I 823 Apartments

I 823 I 8th Avenue

EARLY DESIGN GUIDANCE / RECOMMENDATIONS

EDG - OPTION C “STREET COURTYARDS”

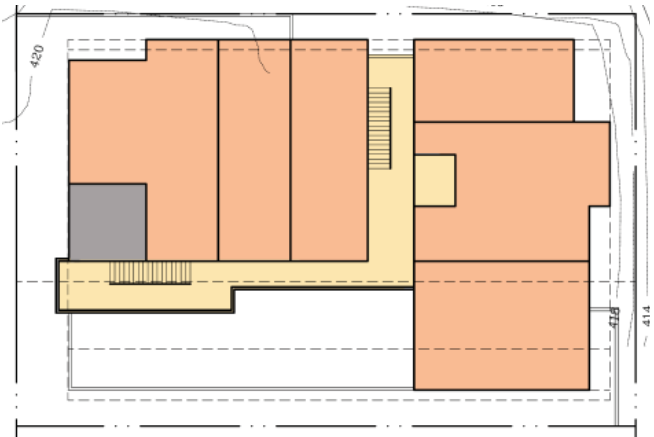
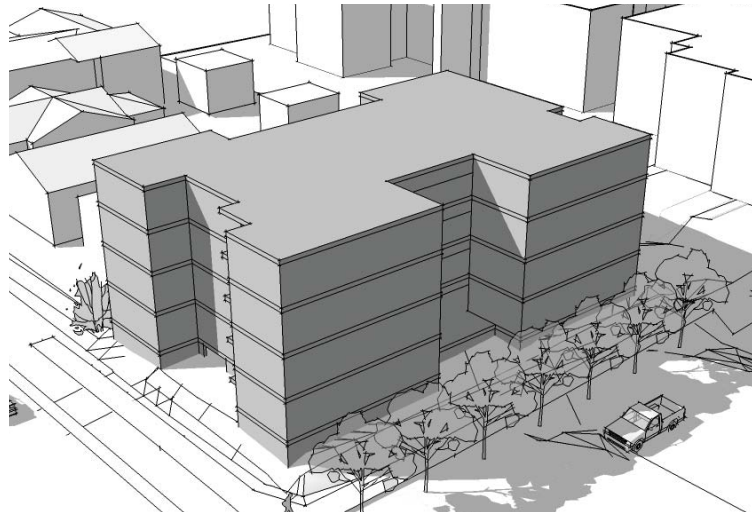
ALLEY ACCESS PARKING: Parking access should be from the alley.

MODULATION: The board appreciated how this option broke up the structures massing along the street facades.

OPEN SPACE: The board favored a scheme where open space was distributed throughout the project, the strong street-side modulation of this option supported that desire.

CONSISTANT DETAILING: The board encouraged simplified and consistent detailing, especially at rooflines. Option C offered quieter detailing which minimized the attention of the structure's scale.

EDG - OPTION D “TREE COURT - PREFERRED SCHEME”

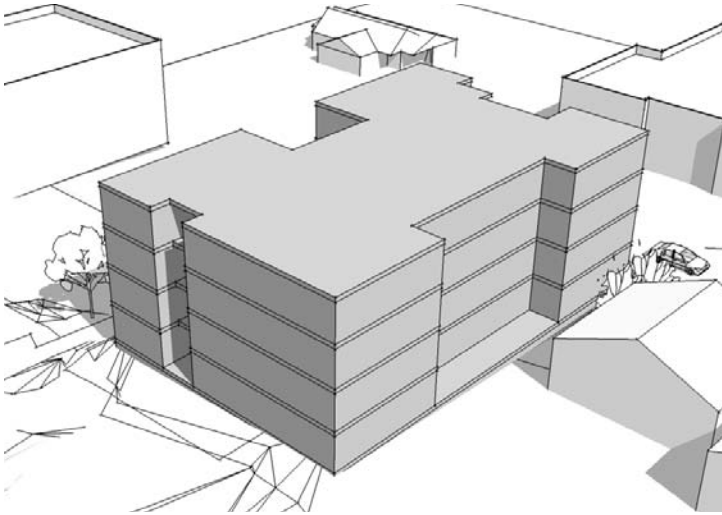
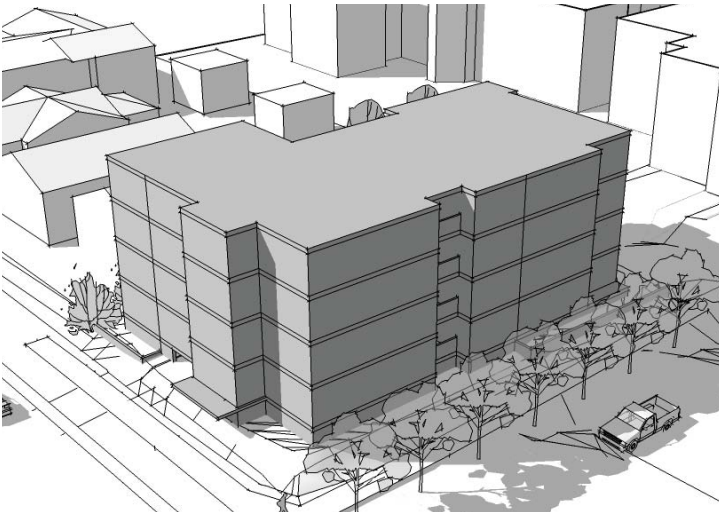
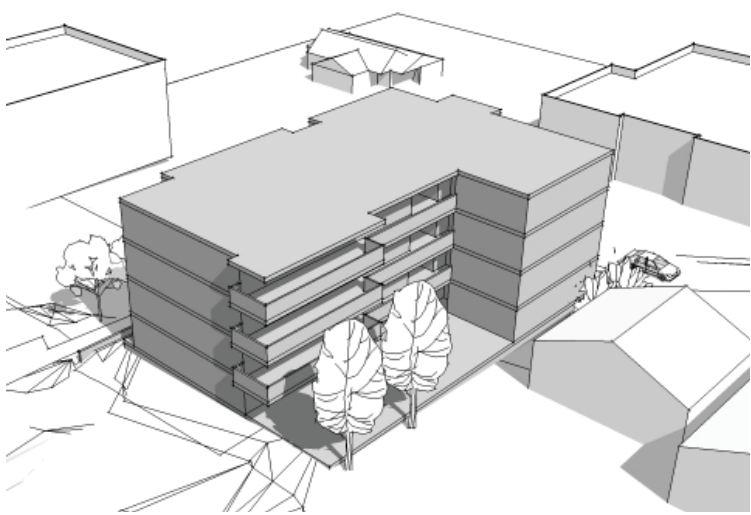
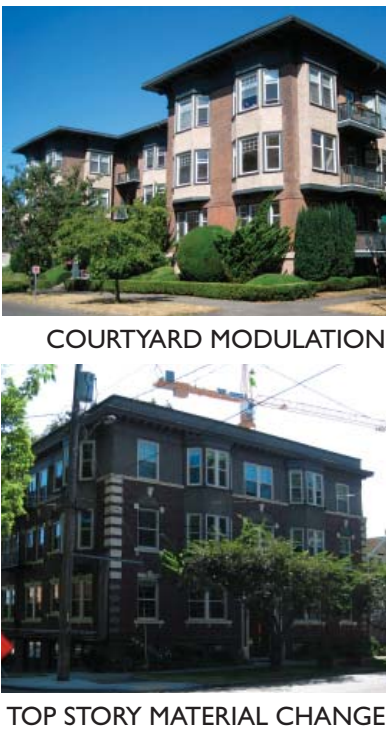
ALLEY ACCESS PARKING: Parking access should be from the alley. The massing configuration of Option D offers an opportunity to place the parking ramp from an alley access point at the current Southwest courtyard location. A combination of a ramp in this location with the streetside courtyards of Option C was strongly encouraged as a massing direction for the project.

MASSING: The gesture of a Southwest courtyard increases the perceived massing of the project along the streetscape. Massing should reflect the neighborhood scale and be reduced, such as in upper level setbacks or strong modulation.

CONNECTION TO STREETSCAPE: The board expressed concern about potential blank wall conditions at sidewalk grade where parking level occurs and encouraged units at grade level as an alternative.

SUMMARY OF CHANGES

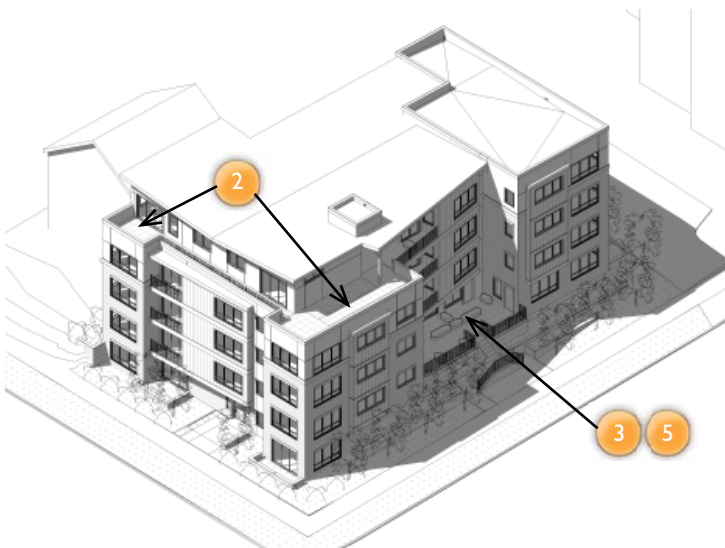
The Design Review Board noted aspects of Option C as preferred for the final design proposal. These aspects included a strong streetside building modulation along both East Denny Way and 18th Avenue and the distribution of open space throughout the project versus a concentration in one location. The Board was open to options for the location and size of the main building entry and stated a favorable openness to its location along 18th Avenue. The Board did not favor parking access from 18th Avenue as proposed during EDG. The Board encouraged the use of a parking ramp in the location of the courtyard presented in Option D (located at the Southwest corner of the site) combined with the desirable building modulation of Option C along the street facades. The Board further encouraged reduced massing at the upper level, units at sidewalk grade where possible, and detailing consistent with the neighborhood. The proposed project represents a combination of both Options C and D in response to the comments and guidance given at the February 8th, 2012 EDG Meeting. The changes are summarized below:

- 1 ALLEY ACCESS PARKING: Parking ramp located along south property line and accessed from alley.
- 2 MASSING REDUCTION: The top level of the structure has been pulled back from the NE corner of the site and along the entire facade of 18th Avenue. The area will be use for a combination of common area roof deck space and private roof deck space. Structure at NW corner steps back away from alley entrance and sidewalk to create additional landscaping and transisional space to alley ROW.

- 3 MODULATION: Courtyards located along 18th Avenue and East Denny Way. Facade modulation in the form of bays are located throughout project.
- 4 CONSISTENT DETAILING: Use of materials and locations, as well as parapet roof detailing, is consistent with both neighborhood and within building itself. Bays use the same detailing and window configurations and are located consistently throughout the project. Use of metal is consistent color and finish and limited to bays, entry gates, screening, railings, and stairs.

- 5 OPEN SPACE: Private open space is provided within courtyard along East Denny Way and 18th Avenue, as well as a roof garden.
- 6 CONNECTION TO STREETScape: Units at street-level created along 18th Avenue and the corner of 18th and Denny. Courtyard along East Denny Way makes a strong gesture to the street with plantings and stair access. Units have direct access from courtyard to actively engage the space.
